City of Portland, Maine - Building or Use Permit Application 389 Congress Street, 04101, Tel: (207) 874-8703, FAX: 874-8716

**Minor/Minor Site Review for New Detached Single Family Dwelling,
All Purpose Building Permit Application**

Project description: Build partial partitions, sheetrock, and insulate existing unfinished second floor. Rail for existing porch.

BUILDING PERMIT REPORT

Second Floor

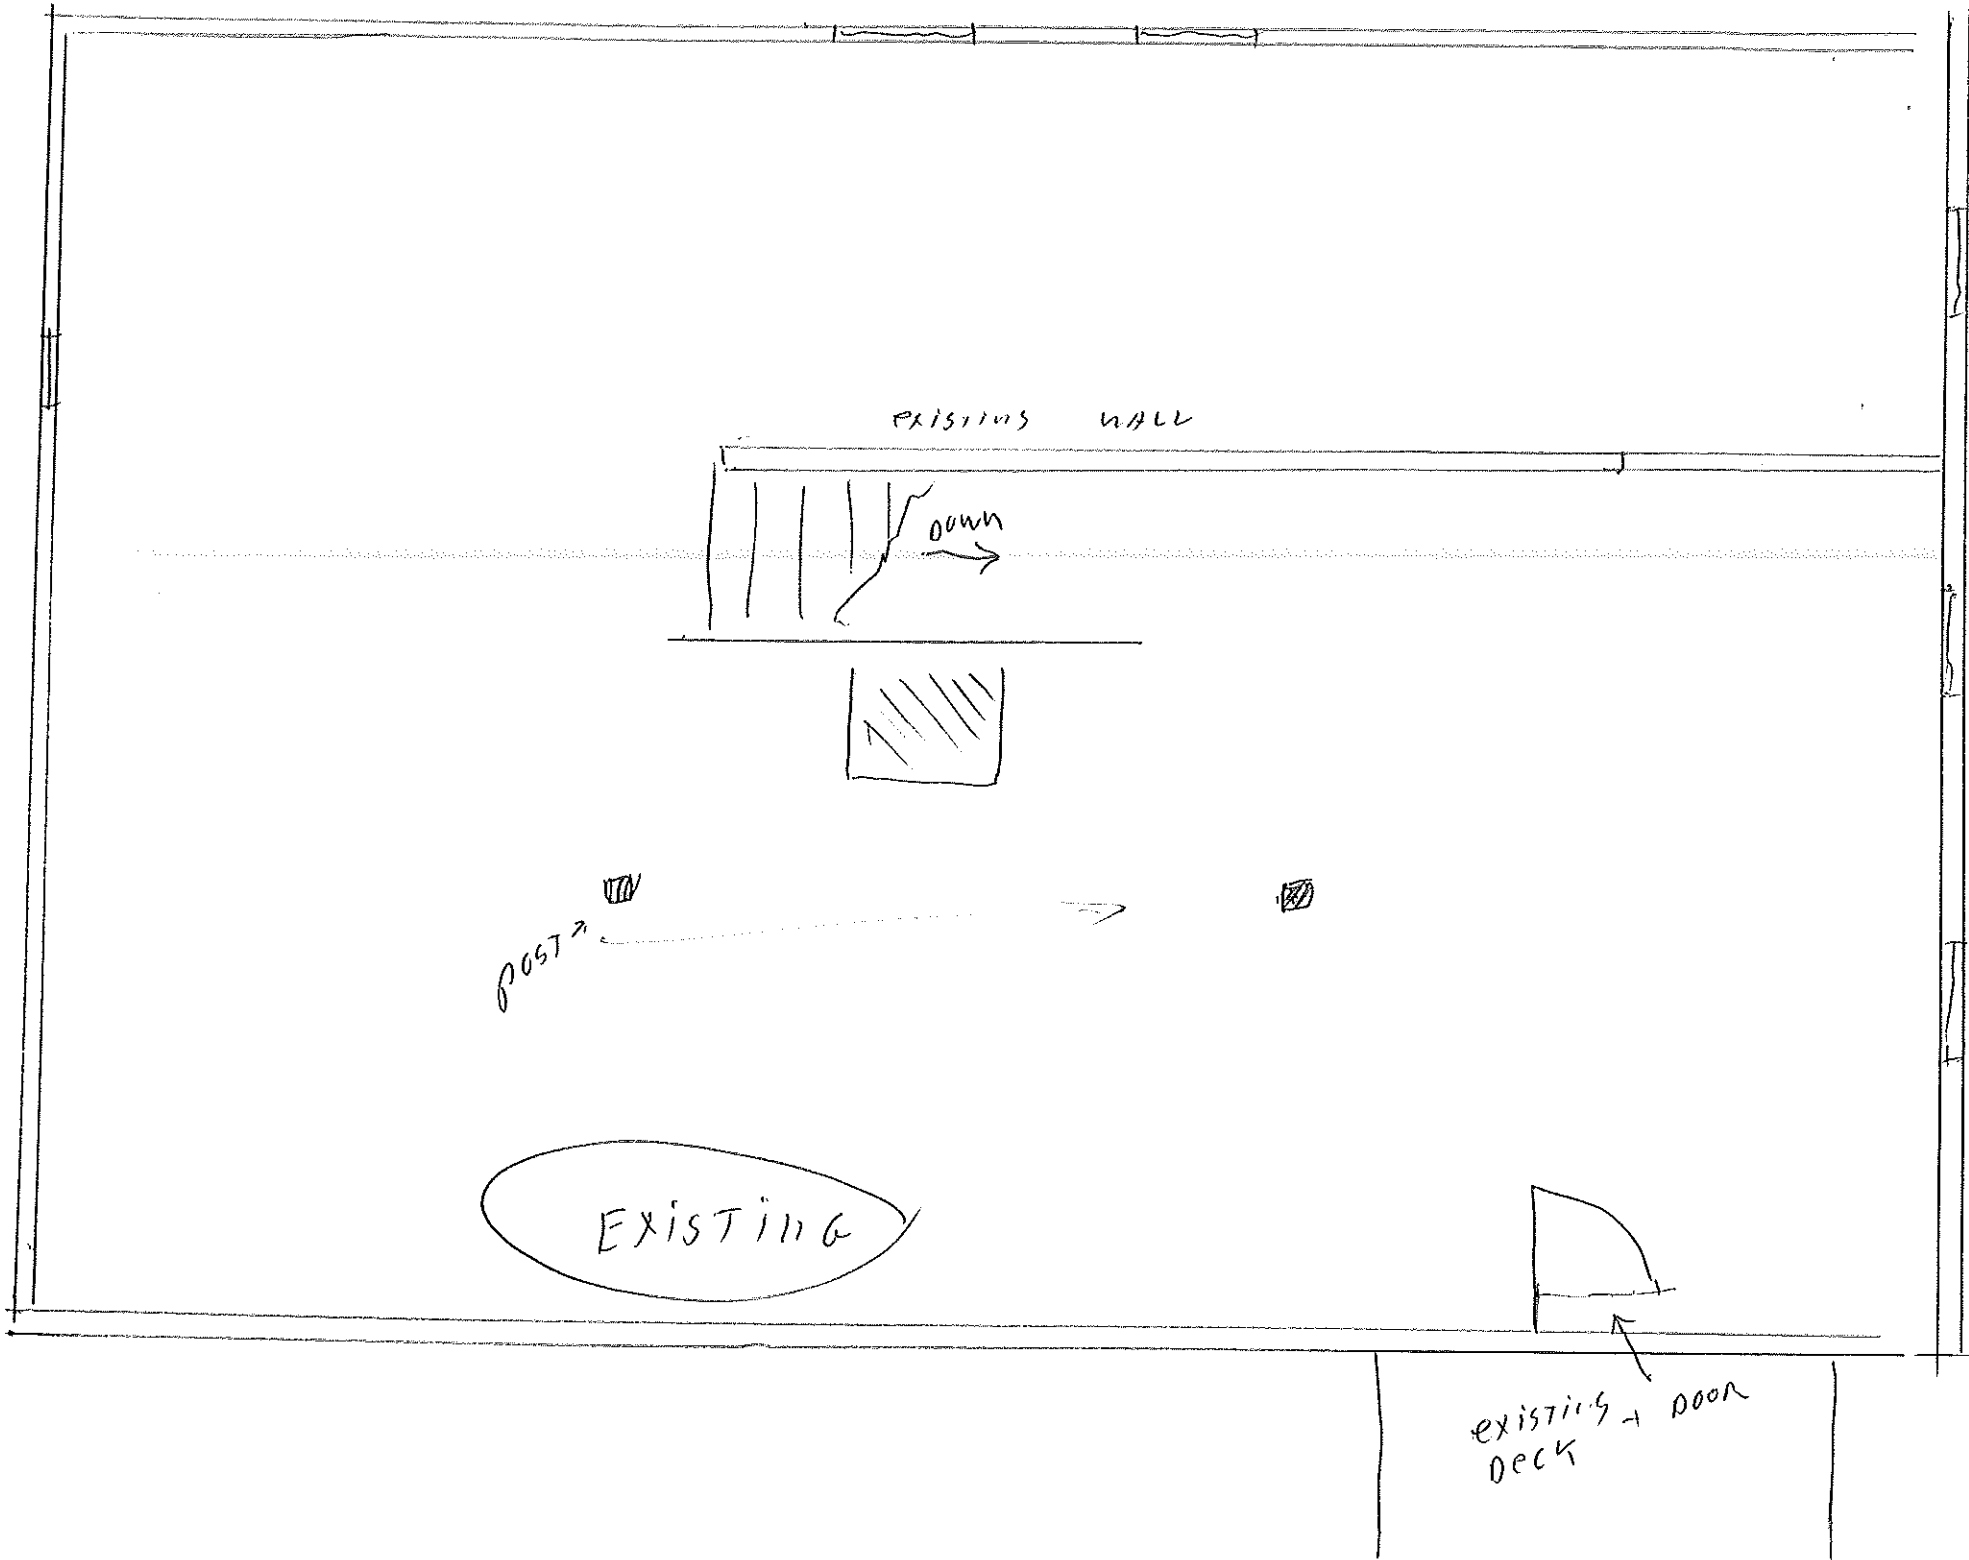
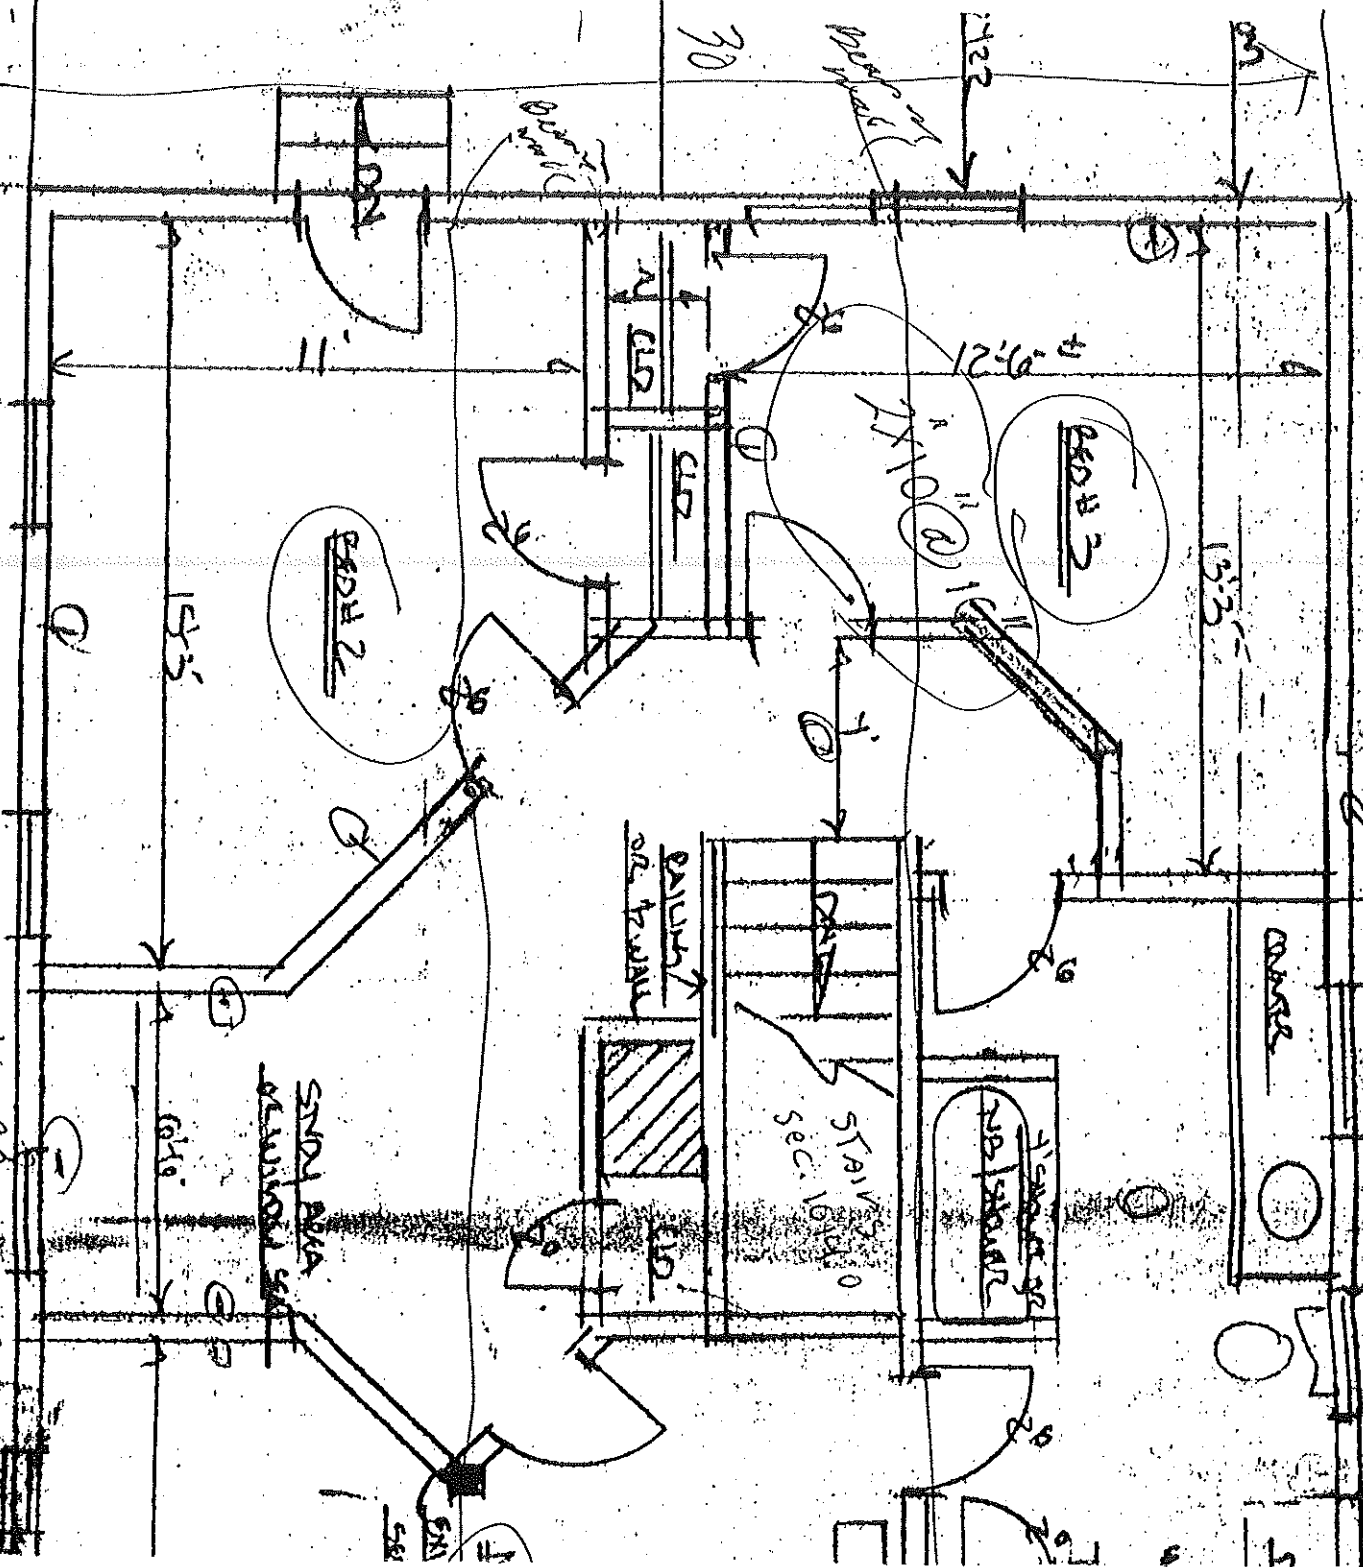
your plans did not have a floor framing detail (existing) - the blade cable repairs started, a design here load of 30 PPS for sleeping areas - before any work is started, a complete framing detail shall be submitted and approved

STAIRS
SEC. 10/4.0

Rail 4 1/2" high
2x2 4" on cen

STAIRS Sec. 1604.0

Rail 42" high
2x2 4" on center
